UNITED STATES
NUCLEAR REGULATORY COMMISSION
WASHINGTON, D. C. 20555

SUBJECT: ARKANSAS NUCLEAR ONE; INCIDENT ON SEPTEMBER 16, 1978; AUTO
TRANSFER OF AUXILIARY LOADS ON BOTH UNITS TO STARTUP TRANSFORMER
NO. 2 WITH CONSEQUENT OVERLOAD; CONFORMANCE TO GDC-17

Description of the Offsite Power System
Design for Arkansas Nuclear One
Units 1 and 2

SIMPLIFIED LINE
DIAGRAM
AND UNITS I & 2

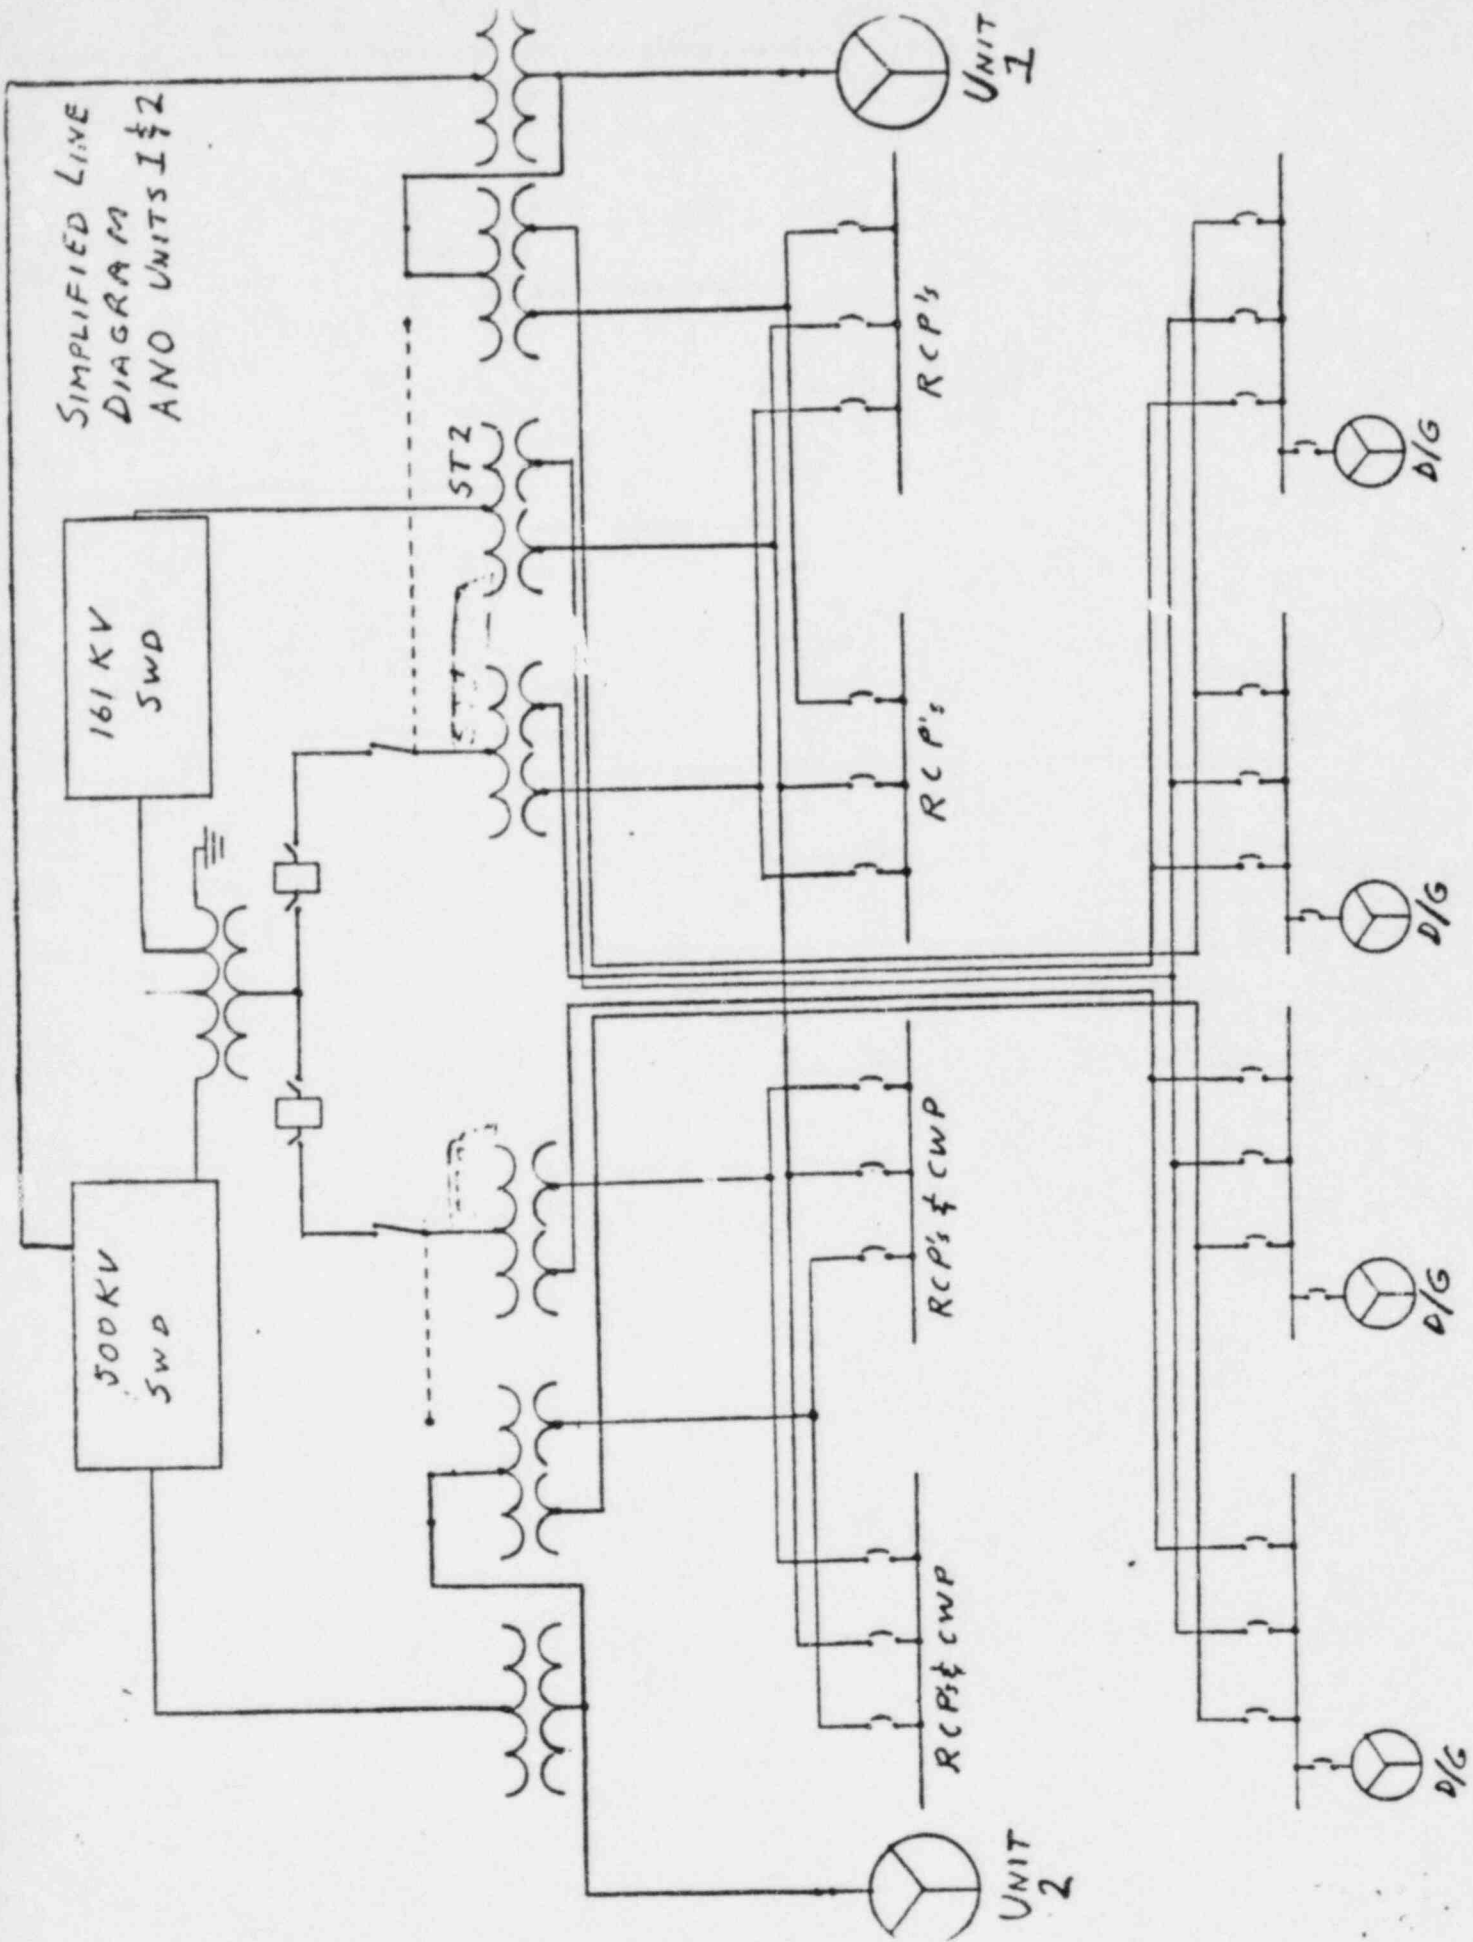
- 5) When both units are being supplied by their respective ST's and the common source of power to the ST's (the autotransformer) is lost, then the auxiliary loads of both units will be automatically transferred to ST2. This will overload ST2 (exceed MVA rating) and also produce excess voltage drop resulting in a degraded voltage condition at the buses (safety and non-safety) of both units.

- 6) With the existing design, the overloading of ST2 will result automatically on failure of the autotransformer circuit feeding the two dedicated startup transformers, when the failure occurs concurrently with the following conditions or events:

- a) both units in either the startup or shutdown modes of operation,
 - b) trip of one unit while the other is in either the startup or shutdown mode of operation, and

- c) simultaneous trip of both units.

It is noted that item 6(b) above covers the incident which occurred at ANO on September 16, 1978. Specifically, this incident was

initiated by a spurious trip of Unit 1 while Unit 2 was in the startup mode. This resulted in automatic transfer of the Unit 1 auxiliary loads from its UT to its ST. Since Unit 2 was already on its ST, this transfer loaded the autotransformer with the full auxiliary loads of both units, resulting in trip of an autotransformer overcurrent relay (which had not been adjusted for two unit operation) and consequent opening of the circuit breakers feeding the two ST's. Loss of the ST's automatically transferred the auxiliary loads of both units to ST2 exceeding its MVA rating and producing a degraded voltage at the auxiliary buses (safety and non-safety) of both units. The overcurrent protective relaying for the autotransformer has since been corrected to preclude recurrence of this type of failure.

We have already indicated to you that we will require that Unit 2 be in compliance with General Design Criteria-17 prior to NRC authorization for Unit 2 operation in Mode 2 (Startup). Acceptable options for attaining conformance with GDC-17 include:

1. Replacement of Startup Transformer No. 2 with one capable of carrying the worst case combination of automatically transferred loads.
2. Defeat of all capability for automatic transfer of loads to Startup Transformer No. 2.
3. Defeat of capability for automatic transfer of selected loads such that Startup Transformer No. 2 will never experience an overload condition (including excess voltage drop resulting in unacceptable voltage at the safety buses) due to the worst case combination of the retained automatic load transfer capability.

Acceptable means of implementing Option 3 above include: (1) defeat of automatic load transfer in one unit while retaining it in the other, or (2) partial defeat of automatic load transfer in either or both units.
